Sheringham Shoal and Dudgeon Offshore Wind Farm Extension Projects

The Applicant's Comments on the Maritime and
Coastguard Agency's Deadline 7 Submission

Document Reference: 22.25

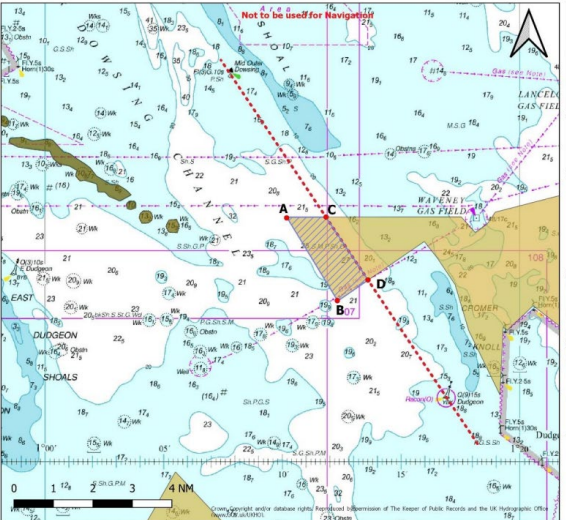
ID	Question	Maritime and Coastguard Agency Responses	Applicant's Comment
	<p>a) Applicant and MCA, show this exclusion zone on a map/diagram with an easily recognisable title.</p>	 <p>Figure 1 Recommended 'exclusion area' (blue hatched area) or reduction in f</p>	
	<p>b) In its post Examination considerations, if the ExA considers it is essential to include a provision for an infrastructure free zone in line with MCA's representations (as outlined in Section 7 and Figure 2 (Recommended Boundary Amendment) of their submission at Deadline 5) [REP5-081], Applicant and MCA advise if the map/diagram would need to be included as a certified document or if it should be included in the ES or the Offshore Project Environmental Management Plan.</p>	<p>MCA would suggest that the image showing the 'exclusion area' is referenced in the DCO as a certified document and included in pre-construction plans and documentation.</p>	<p>It is the Applicant's view that, should it be deemed essential by the Secretary of State to include provision for a surface structure free area then this would be most appropriately secured via the Offshore Works Plans without need to certify the attached figure or have it included in any other post consent documentation. See the response to Q4.19.1.6c of The Applicant's Responses to the Examining Authority's Fourth Written Questions [document reference 21.5] and the Works Plans (Offshore) (Without Prejudice) (Revision B) [document reference 2.7.2].</p>

<p>c) Applicant and MCA, provide dDCO drafting, be it a new article, new</p>	<p>MCA would suggest that latitude and longitude coordinates of the 'exclusion area' are included</p>	<p>The most straightforward mechanism to secure a surface structures free area within the Order Limits at DEP North</p>

ID	Question	Maritime and Coastguard Agency Responses	Applicant's Comment															
	<p>requirement or amendment to an existing requirement, and any relevant definitions that puts the exclusion zone into effect.</p>	<p>in the DCO, for example: None of the infrastructure listed in Work No.*** may be installed within the area defined by the coordinates as specified below and no part of any wind turbine generator, including its blades, may overfly into the area:</p>

<p>This wording is taken from another offshore wind farm DCO where a similar 'exclusion area' was proposed. MCA would also suggest that pre-construction plans required under the DML conditions e.g. construction programme and Offshore Project Environmental Management Plan, should include details of any works to be undertaken within the 'exclusion area', such as cables, and a timetable of works to be undertaken.</p>	Point ID of the area	Latitude (D°M.MM')	Longitude (D°M.MM')	A (NW corner)	53° 21.1541' N	1° 10.185	B (SW corner)	53° 19.0449' N	1° 12.332	C (NE corner)	53° 19.5696' N	1° 13.610	D (SE corner)	53° 21.1558' N	1° 11.834	<p>in the Draft DCO is to alter the Offshore Works Plans. It is not necessary to have a new article, Requirement or other provision (nor to amend any existing articles, Requirements or other provisions) to achieve a surface structures free area. See the response to Q4.19.1.6c of The Applicant's Responses to the Examining Authority's Fourth Written Questions [document reference 21.5] and the Works Plans (Offshore) (Without Prejudice) (Revision B) [document reference 2.7.2].</p>
Point ID of the area	Latitude (D°M.MM')	Longitude (D°M.MM')																
A (NW corner)	53° 21.1541' N	1° 10.185																
B (SW corner)	53° 19.0449' N	1° 12.332																
C (NE corner)	53° 19.5696' N	1° 13.610																
D (SE corner)	53° 21.1558' N	1° 11.834																
	<p>f) Applicant and MCA, to provide responses to the above questions in agreement in a joint statement.</p>	<p>MCA and the Applicant are not in agreement with the above 'exclusion area' and an agreed joint statement has not been reached.</p>	<p>Noted.</p>															
<p>Q4.19.1.10</p>	<p>Joint Position Statement ExA requires a joint position statement from both parties to set out what is a mutually</p>	<p>MCA recommends either a reduction to the RLB or commitment to an 'exclusion area' (as above) is required to reduced navigational risks to ALARP. This is opposed by the Applicant and as</p>	<p>Noted.</p>
